DS-K1T642 Series MinMoe Terminal Release Notes (2022-02-09)

DS-K1T642 Series MinMoe Terminal Release Notes (2022-01-04)

DS-K1T642 Series MinMoe Terminal Release Notes (2021-02-08)

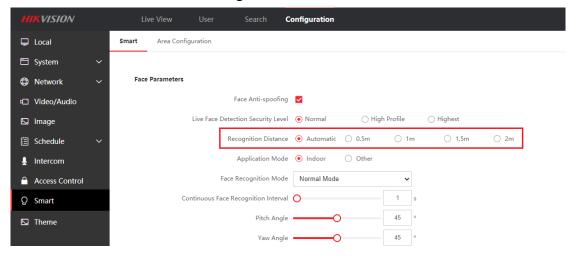
1. Add Hik-Connect menu in device UI Menu→Comm. The function is disabled in default.

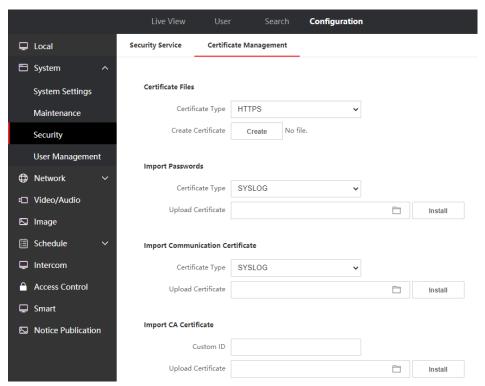
1. Support https feature

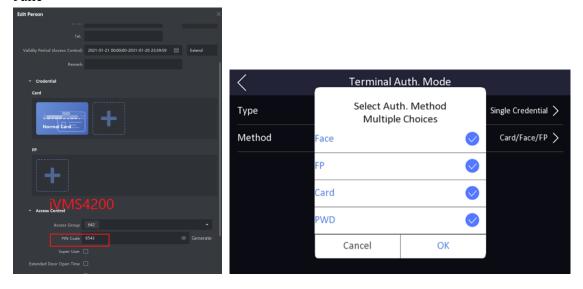
5. Add ISAPI event monitoring upload (HTTP listening) function

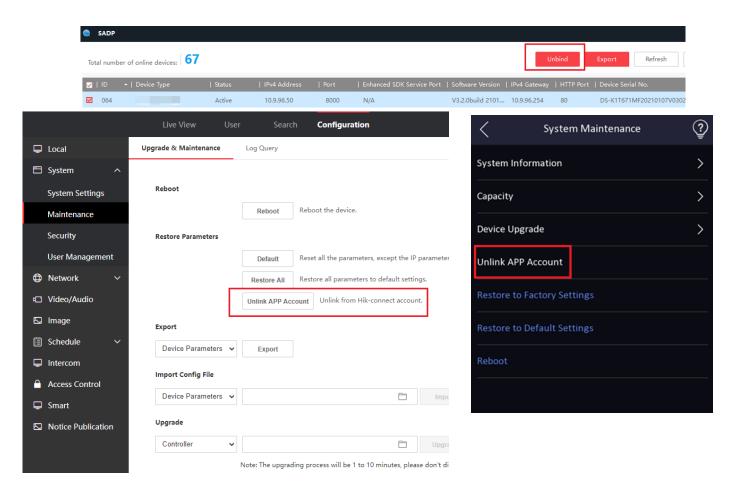
- 6. Open the door with PIN code (disabled in default).
- 7. Note: PIN code should be configured from software, iVMS4200 already support, HikCentral Pro will support PIN code configuration in V2.1 expected to be released in June

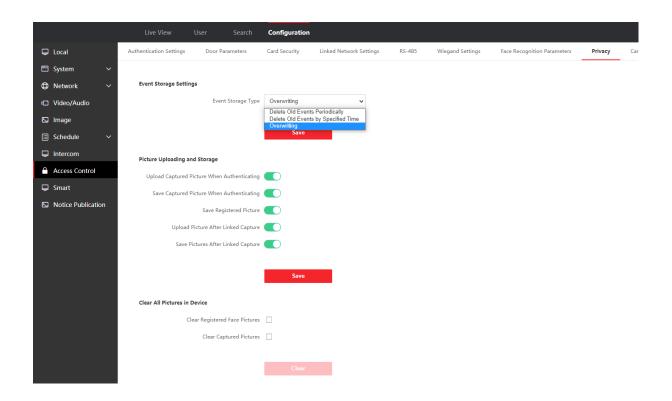
10. Add help interface to check system module version for technical support (long press for 3s).

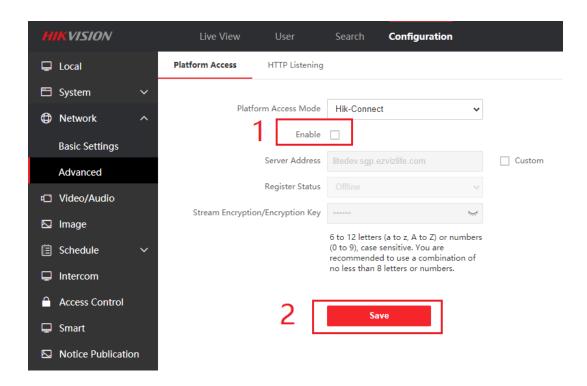
4. Hik-Connect function is turned off in default for privacy protection, if customer want to manage device from App, please turn on manually in the web.

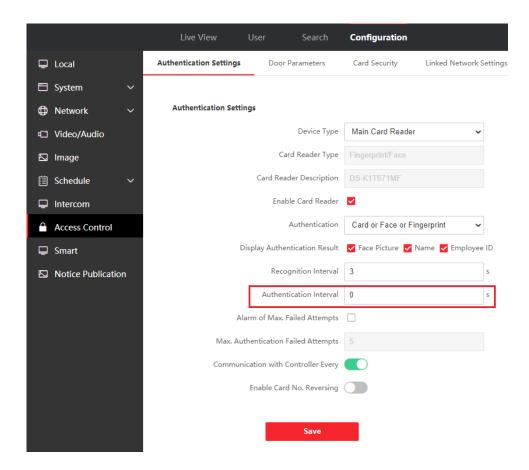
- 5. The face matching algorithm is upgraded. Improve the speed and accuracy of face recognition. Improved the recognition effect of dark masks
- 6. DNS can be configured from device UI in menu→Comm.-->Wired Network

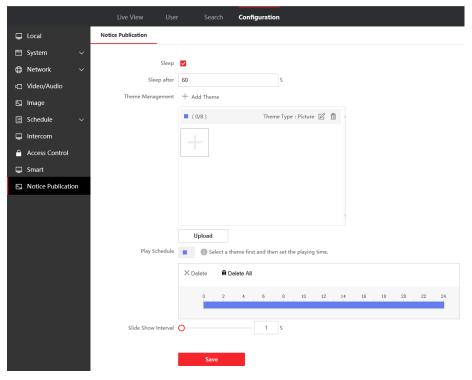
- 7. Optimized the ISUP and Hik-Connect event upload mechanism.
- 8. Add stranger authentication timeout time configuration.
